Application Note AN-1101

IRS210(8,84) and IR210(8,84) Comparison

Figure 7A. Turn-off Fall Time vs. Temperature

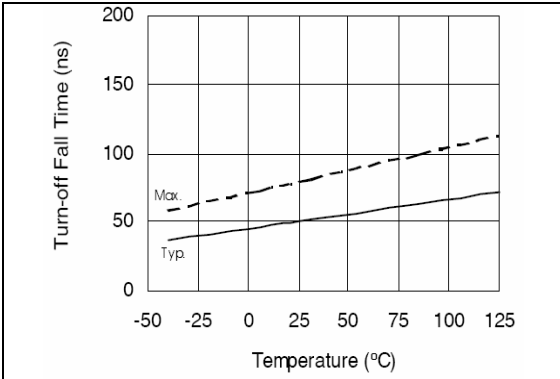
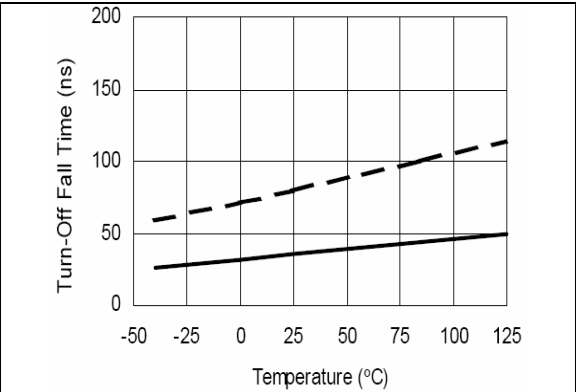
The IRS210(8,84) have faster rise and fall times when compared to the IR210(8,84).

This figures shown in this section compare figures shown in the IR210(8,84) (left column) and IRS210(8,84) (right column) datasheets. Illustrations that have not changed between the two datasheets have not been included in this section.

Figure 9A. Logic "1" Input Voltage vs. Temperature

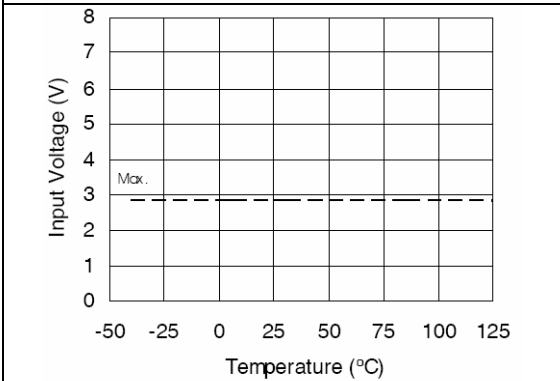
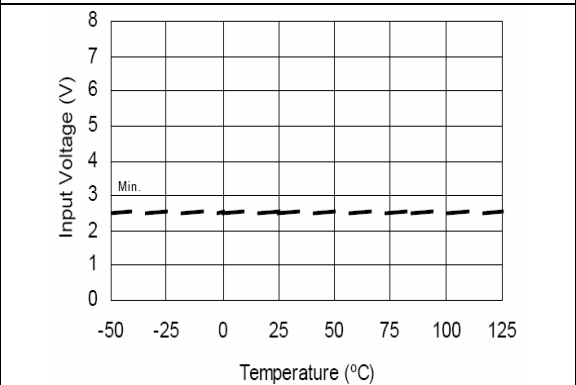
- V_{IH} is reduced to 2.5 V for better 3.3 V logic compatibility.
- The V_{OH} and V_{OL} are tested using a new standardized test condition of $I_O = 2$ mA. The output driver's on resistance is lower for IRS210(8,84), which improves immunity against the Miller effect.
- The typical values for I_{O+} and I_{O-} are increased, which allows faster switching.
